**ADDENDUM #5**

**Will County Health Department**  
**BID PACKAGE #2 – Misc. Steel/Structural/Enclosure**  
**November 15, 2018**

**SECTION 00 91 07  
BP #2 - ADDENDUM NUMBER 5**

**PROJECT:**           **WILL COUNTY HEALTH DEPARTMENT - NEW HEALTH DEPARTMENT  
BUILDING  
501 ELLA AVENUE  
JOLIET, ILLINOIS 60433**

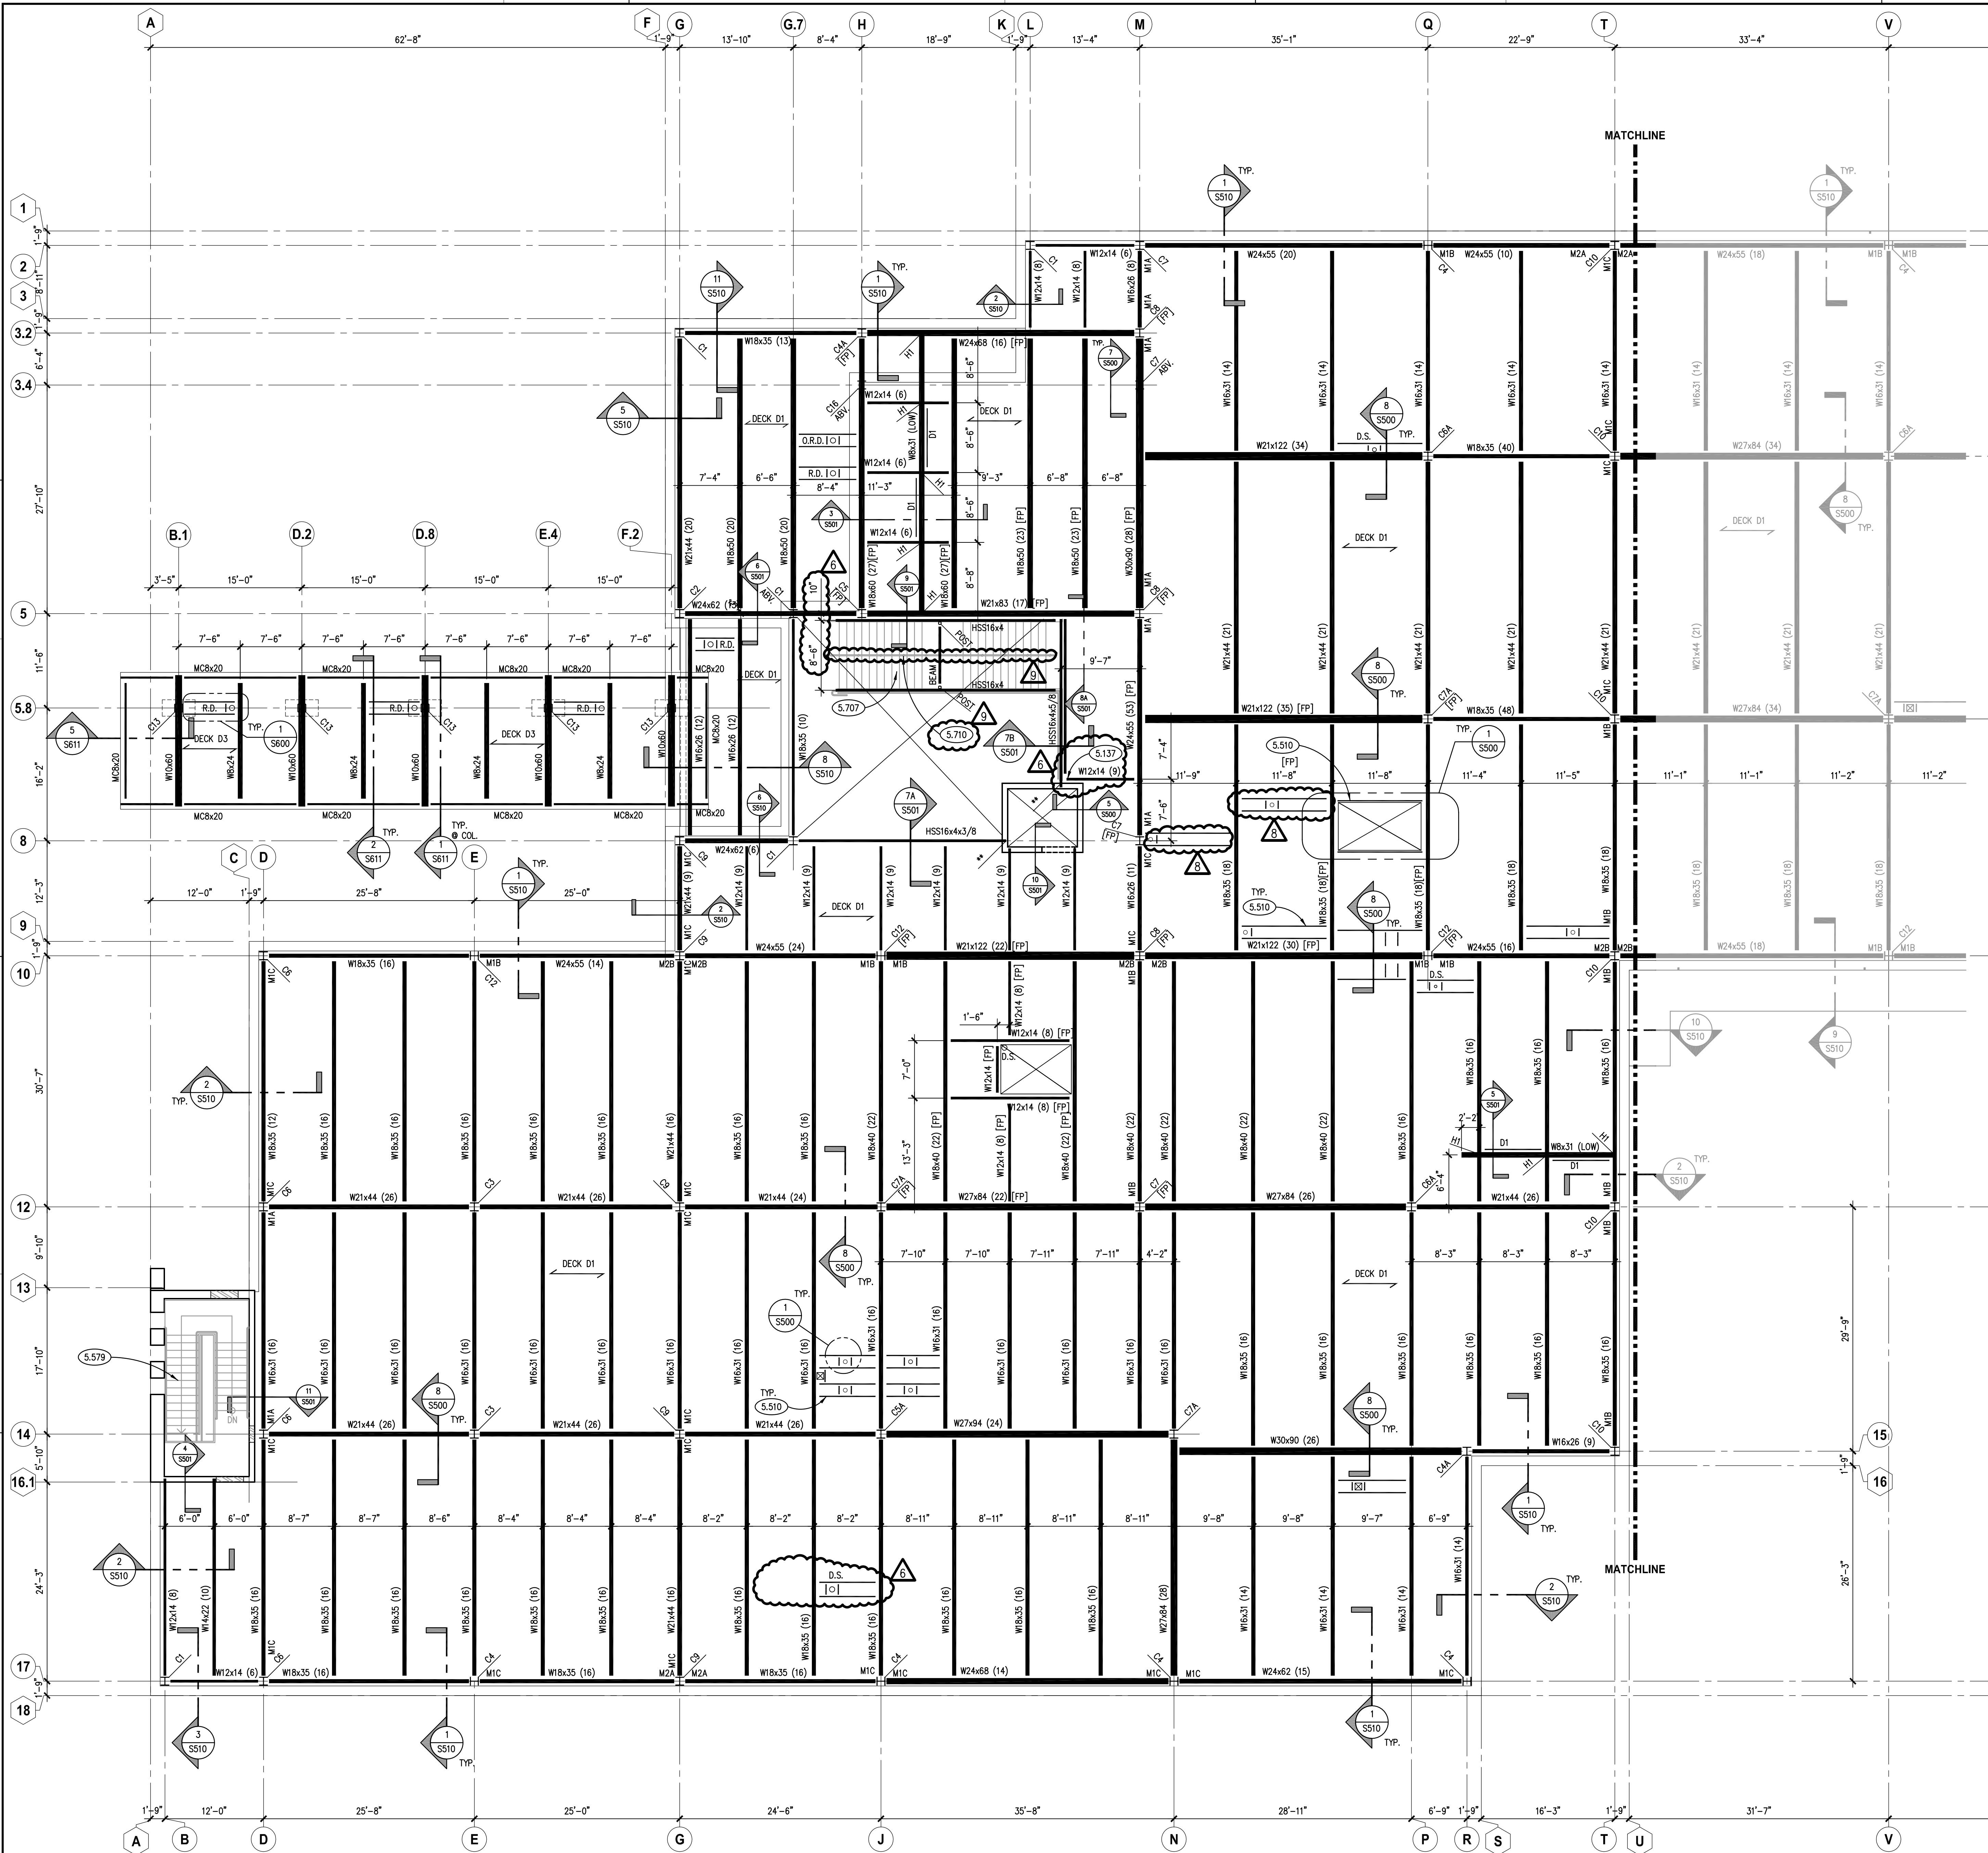
- A. Revisions to the weather barrier coating placement and termination points. Minor modifications to the details as noted. Refer to revision cloud 9 for specific changes.
- B. Added General Note #6.

- A. Revisions to the weather barrier coating placement and termination points. Minor modifications to the details as noted. Refer to revision cloud 9 for specific changes.
- B. Added General Note #6.

PARTIAL SECOND FLOOR FRAMING PLAN - AREA 'A'  
SCALE: 1/8" = 1'-0"

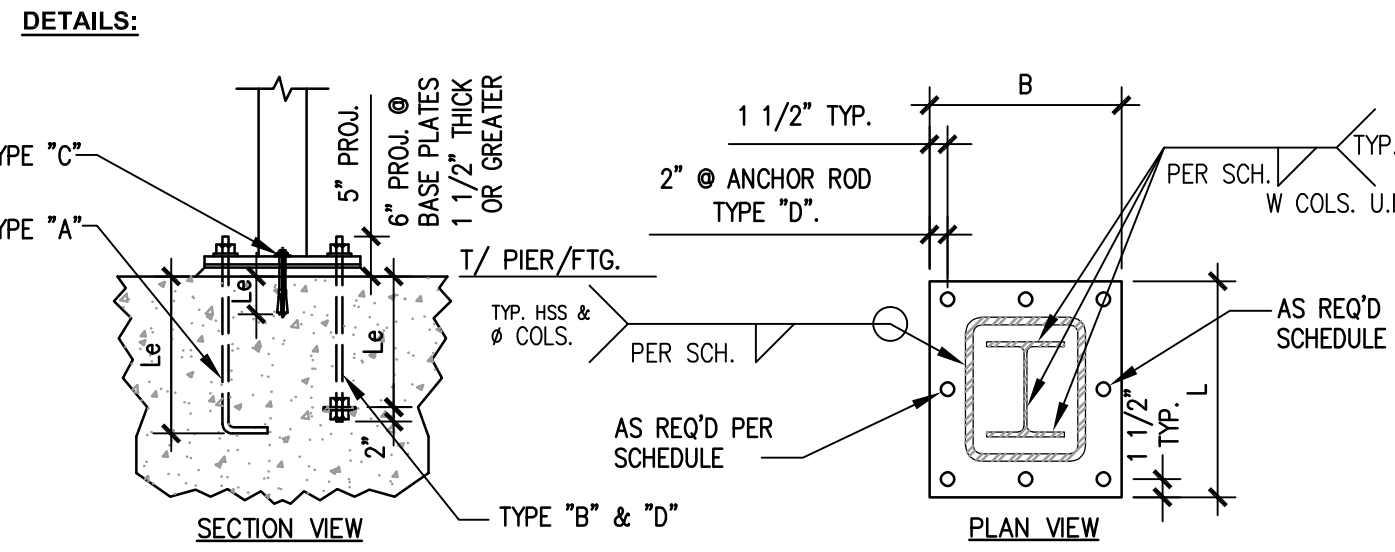
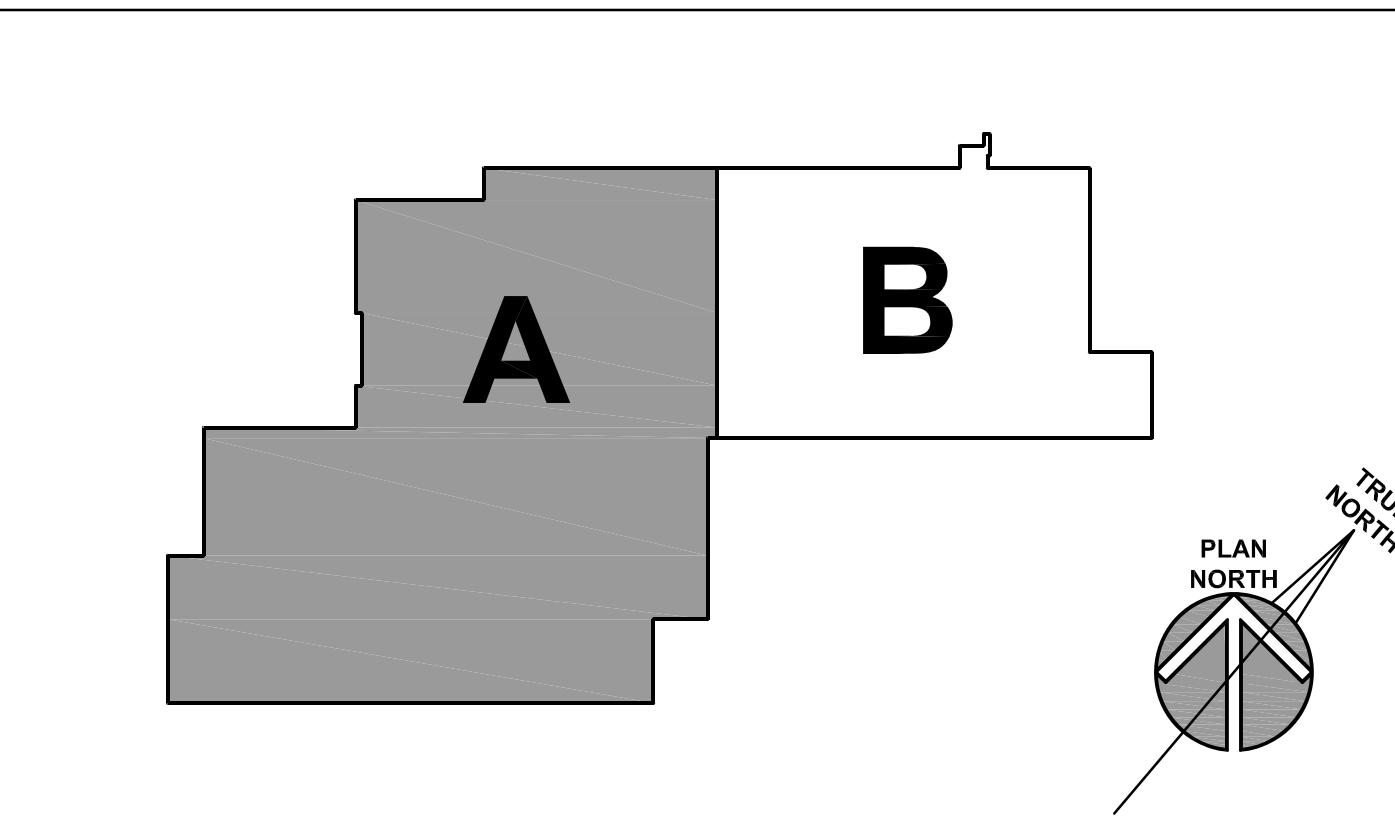
- A. Delete drawing in its entirety and replace with drawing number S321 (attached). Refer to revision cloud 9 for specific changes.
